British Gliding Association – Technical Committee**Technical News Sheet 11/12/01****Part 1** Airworthiness issues (all categories)

BULLETIN DE SERVICE

SERVICE BULLETIN NO. MSB306-36/2

N° 201-21

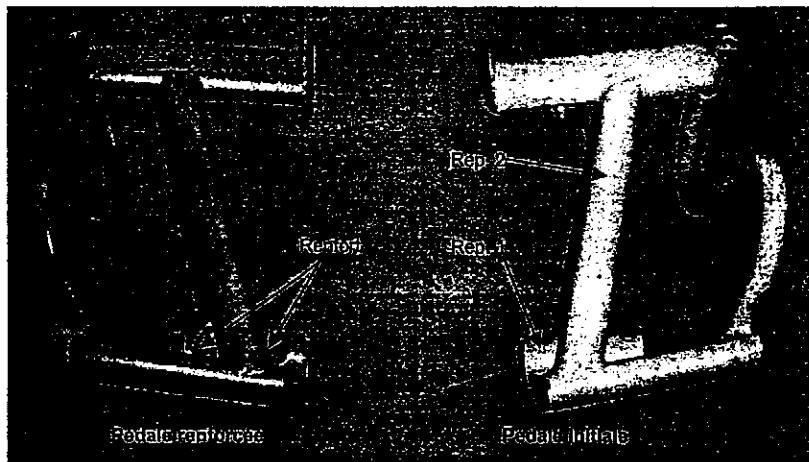
OBJET : CONTROLE ET REMPLACEMENT PEDALE DE PALONNIER AVANT

BUT : Vérifier l'absence de criques sur les pédales et remplacement des pédales initiales par des pédales renforcées pour éviter l'évolution éventuelle d'une amorce de crique si celle-ci n'est pas vue en cours de visite annuelle

En cas de surcharge, un risque d'apparition de crique peut survenir au niveau de la soudure entre le tube d'articulation et le tube vertical des pédales de palonnier (constaté sur un planeur accidenté ayant des pédales de même type que le planeur SN CENTRAIR 201).

1. Contrôler sous un mois l'état de la soudure entre le tube d'articulation (repère 1) et le tube vertical (repère 2) sur les 2 pédales de palonnier avant afin d'y déceler un éventuel début de crique. Ce contrôle doit être fait par ressuage (pénétrant Ardrox 996P2 et révélateur 9D1 par exemple) après décapage local de la peinture. En cas de découverte d'amorce de crique, le remplacement de la pédale est impératif avant tout nouveau vol.
2. Remplacer sous un an maxi et au plus tard lors de la prochaine visite annuelle les pédales non renforcées par des pédales réf. \$Y185A (pédale gauche) et \$Y196A (pédale droite).

APPLICATION : Vérification sous 1 mois après la date d'émission de ce bulletin de service, remplacement sous un an et au plus tard à la prochaine visite annuelle.

Une notice explicative est disponible à SN CENTRAIR pour le démontage et remontage des pédales, et installation et réglage des câbles de direction (document 201BE1660)

N° 101-24

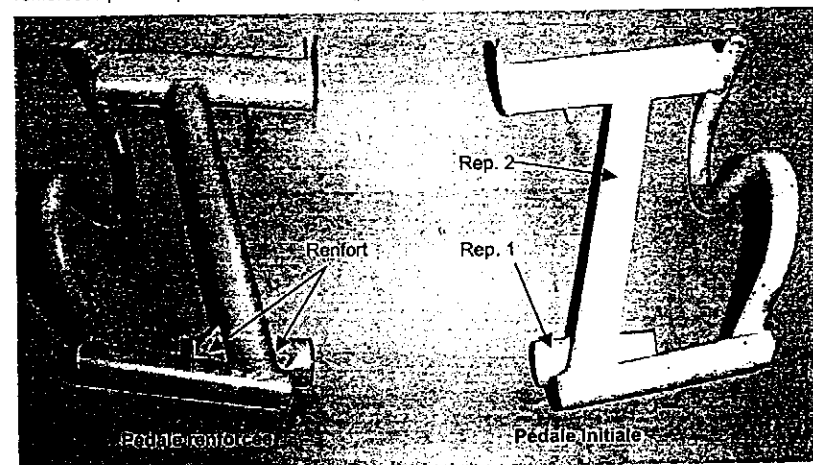
OBJET : CONTROLE ET REMPLACEMENT PEDALE DE PALONNIER

BUT : Vérifier l'absence de criques sur les pédales et remplacement des pédales initiales par des pédales renforcées pour éviter l'évolution éventuelle d'une amorce de crique si celle-ci n'est pas vue en cours de visite annuelle

En cas de surcharge, un risque d'apparition de crique peut survenir au niveau de la soudure entre le tube d'articulation et le tube vertical des pédales de palonnier (constaté sur un planeur accidenté ayant des pédales de même type que le planeur CENTRAIR 101 "Pégase").

1. Contrôler sous un mois l'état de la soudure entre le tube d'articulation (repère 1) et le tube vertical (repère 2) sur les 2 pédales de palonnier afin d'y déceler un éventuel début de crique. Ce contrôle doit être fait par ressuage (pénétrant Ardrox 996P2 et révélateur 9D1 par exemple) après décapage local de la peinture. En cas de découverte d'amorce de crique, le remplacement de la pédale est impératif avant tout nouveau vol.
2. Remplacer sous un an maxi et au plus tard lors de la prochaine visite annuelle les pédales non renforcées par des pédales réf. \$Y185A (pédale gauche) et \$Y196A (pédale droite).

APPLICATION : Vérification sous 1 mois après la date d'émission de ce bulletin de service, remplacement sous un an et au plus tard à la prochaine visite annuelle.

Une notice explicative est disponible à SN CENTRAIR pour le démontage et remontage des pédales, et installation et réglage des câbles de direction (document 101BE1650)

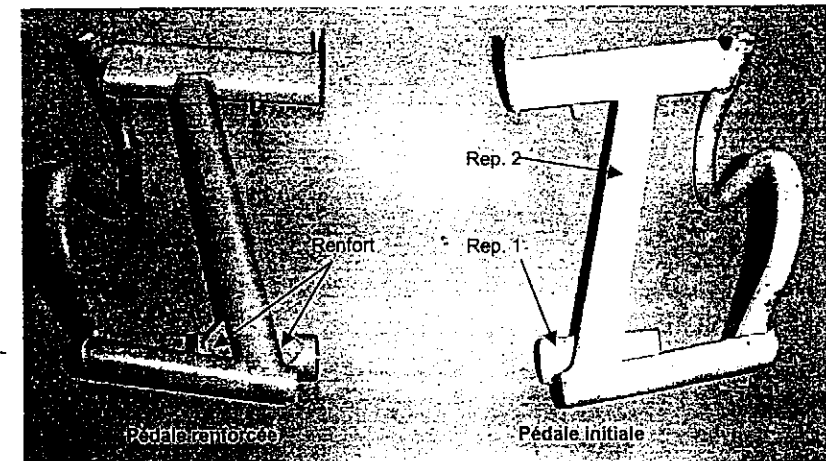
- OBJET :** CONTROLE ET REMPLACEMENT PEDALE DE PALONNIER
- VALIDITE :** Planeurs ASW20F et ASW20FL tous N° de série n'ayant pas eu de remplacement des 2 pédales de palonniers par des modèles renforcés.
- BUT :** Vérifier l'absence de criques sur les pédales et remplacement des pédales initiales par des pédales renforcées pour éviter l'évolution éventuelle d'une amorce de crique si celle-ci n'est pas vue en cours de visite annuelle
- APPLICATION :** Vérification sous 1 mois après la date d'émission de ce bulletin de service, remplacement sous un an et au plus tard à la prochaine visite annuelle.
- DESCRIPTION :**

En cas de surcharge, un risque d'apparition de crique peut survenir au niveau de la soudure entre le tube d'articulation et le tube vertical des pédales de palonnier (constaté sur un planeur accidenté ayant des pédales de même type que le planeur CENTRAIR ASW20F ou FL).

1. Contrôler sous un mois l'état de la soudure entre le tube d'articulation (repère 1) et le tube vertical (repère 2) sur les 2 pédales de palonnier afin d'y déceler un éventuel début de crique. Ce contrôle doit être fait par ressuage (pénétrant Ardrox 996P2 et révélateur 9D1 par exemple) après décapage local de la peinture. En cas de découverte d'amorce de crique, le remplacement de la pédale est impératif avant tout nouveau vol.
2. Remplacer sous un an maxi et au plus tard lors de la prochaine visite annuelle les pédales non renforcées par des pédales réf. \$Y185A (pédale gauche) et \$Y196A (pédale droite).

Une notice explicative est disponible à SN CENTRAIR pour le démontage et remontage des pédales, et installation et réglage des câbles de direction (document 101BE1650)

Red mark at
165 km/h
89,1 kts
102,5 mph

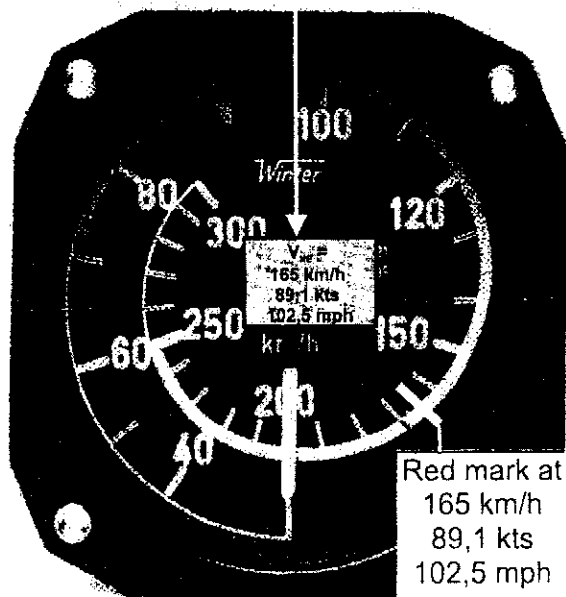
- 1.8.1 Apply a red mark on the airspeed indicator at 165 km/h (89,1 kts, / 102,5 mph)
- 1.8.2 Apply the following red placard (according to airspeed indicator calibration) to the airspeed indicator:

$V_{NE} =$ 165 km/h	$V_{NE} =$ 89,1 kts	$V_{NE} =$ 102,5 mph
------------------------	------------------------	-------------------------
